**REQUEST:** Site Plan Level IV Review: 75-Room Hotel with 984 Square Feet of Ancillary Bar with Request for Dimensional Modifications to Tower Stepback, Tower Separation, Increase in Floor Area Ratio and Request to Pay the Central Beach Parking Facility Fee in the Central Beach Regional Activity Center.

<b>CASE</b>	UDP-S23035	
<b>PROJECT NAME</b>	42 Hotel	
<b>APPLICATION TYPE</b>	Site Plan Level IV	
<b>APPROVAL LEVEL</b>	Planning and Zoning Board Review, City Commission Approval	
<b>REQUEST</b>	75-Room Hotel with 984 Square Feet of Ancillary Bar with Request for Dimensional Modifications to Tower Stepback, Tower Separation, Increase in Floor Area Ratio and Request to Pay the Central Beach Parking Facility Fee in the Central Beach Regional Activity Center.	
<b>APPLICANT</b>	Hariohm Realty, LLC	
<b>AGENT</b>	Stephanie J. Toothaker, Esq	
<b>PROPERTY ADDRESS</b>	3001 Alhambra Street	
<b>ABBREVIATED LEGAL DESCRIPTION</b>	LAUDER DEL MAR 7-30 B LOT 23,24 BLK 6	
<b>ZONING DISTRICT</b>	A-1-A Beachfront Area (ABA) District	
<b>LAND USE</b>	Central Beach Regional Activity Center	
<b>COMMISSION DISTRICT</b>	2 – Steven Glassman	
<b>NEIGHBORHOOD ASSOCIATION</b>	Central Beach Alliance HOA	
<b>D

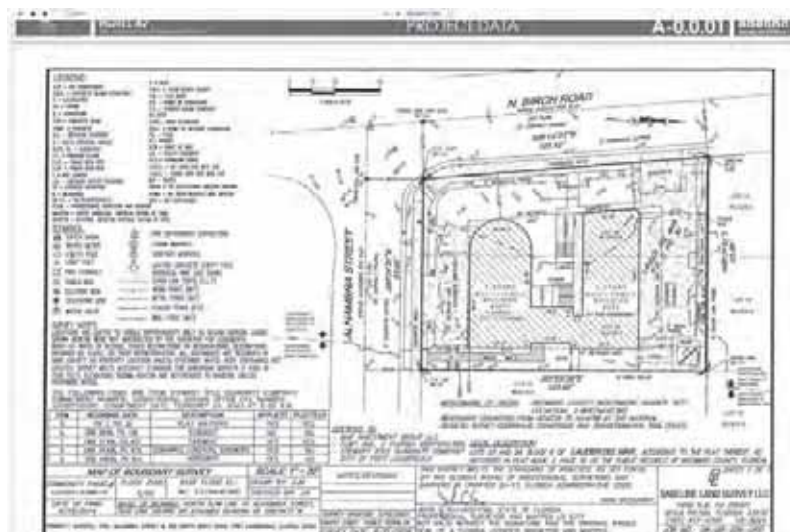
The preliminary maps show a BFE of 8 ft 6ft. NAVD (flood zone "AE") see attachment of the Preliminary Flood Map

**Response:** Ground floor is at the correct flood elevation. 7.0 NAVD

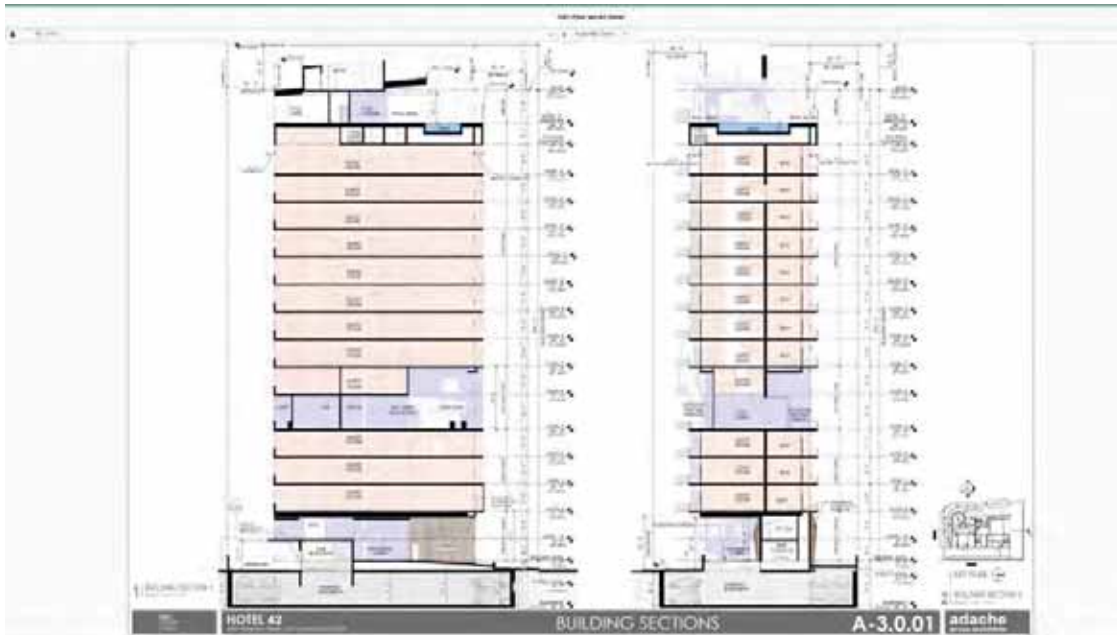
The BFE using the Preliminary Maps is BFE 6 ft. + 1' freeboard = 7 ft. NAVD 88 FFE

See attachment of (site plan A 0 0.05) showing that the Finish floor elevation will not meet the BFE of 8 ft. + 1 ft.=9' NAVD 88 once the preliminary maps go into use.

See attachment of (site plan A 0 0.05) please show that the Finish floor elevation will meet the BFE of 6 ft. + 1 ft.=7' NAVD 88 once the preliminary maps go into use this will be the flood maps in use.

Response: Building is at the correct flood elevation (7.00 NAVD).

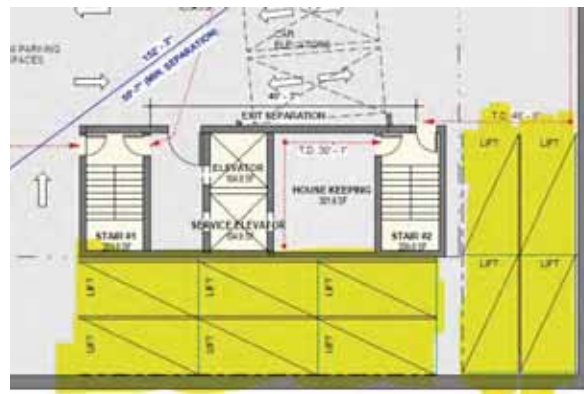
- Reservoir spaces shall be measured from the front of the service position to the rear of the VRS.

14. The VRS service position is the pickup drop off location, the VRS's must be drawn from this location not as it is currently being proposed.

**Response:** Required VRS spaces are provided and comply. Refer to sheet A-1.3.01

**Response:** Internal vehicle circulation was updated. Refer to Sheet A-1.3.01
